UNITED STATES NUCLEAR REGULATORY COMMISSION

In the Matter of	:	
PHILADELPHIA ELECTRIC COMPANY	:	Docket Nos. 50-277
	:	50-278

AMENDMENT TO JUNE 3, 1980
APPLICATION FOR AMENDMENT
OF
FACILITY OPERATING LICENSES
DPR-44 & DPR-56

ORGANIZATION FOR CONDUCT OF
PLANT OPERATIONS

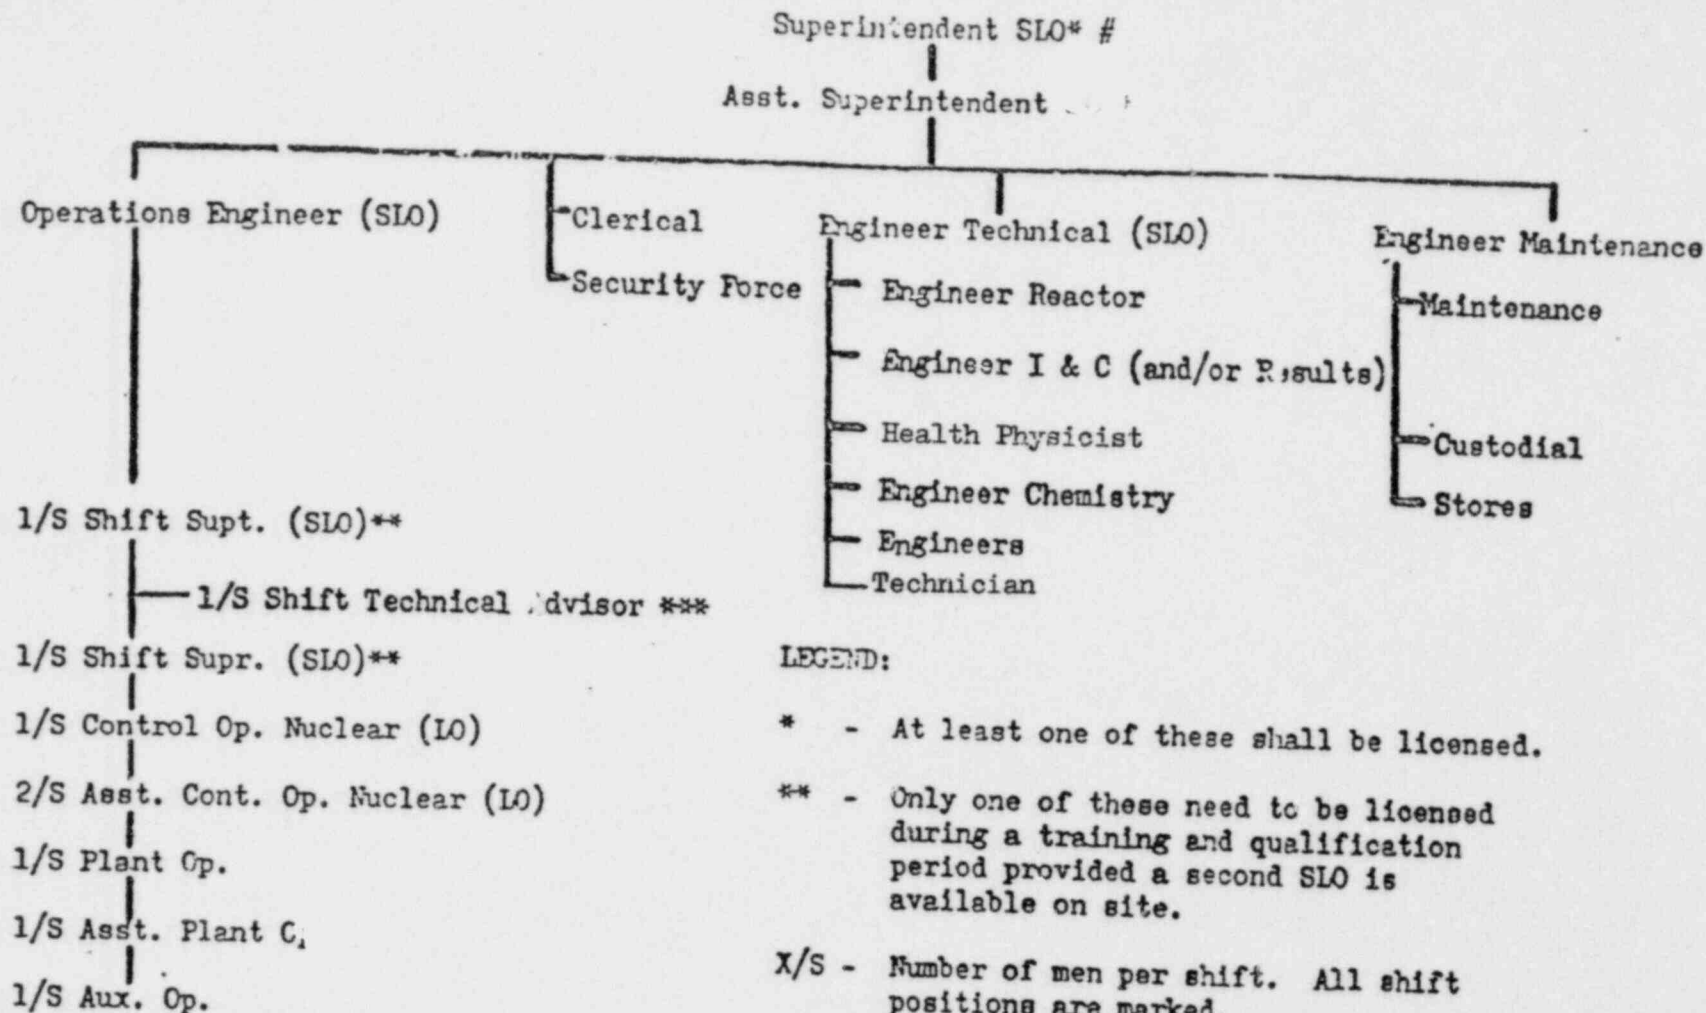
Discussions with the Nuclear Regulatory Commission Staff have indicated that further revisions to the Technical Specifications specifically relating to the Health Physics organization should be made. Accordingly, Licensee hereby amends its Application of June 3, 1980, by deleting the proposed revised pages 245 and 246 from the Application and substituting therefor the proposed revised pages 245 and 246 which are attached hereto and incorporated herein by reference. The amendment to the Application of June 3, 1980, deletes the proposed reorganization of the Health Physics group, while retaining the proposal changing the title "Engineer-Health Physics" to "Health Physicist". The individual presently assigned to this position meets the qualifications of Regulatory Guide 1.8, September 1975, "Guidelines for Radiation Protection Managers Qualifications".
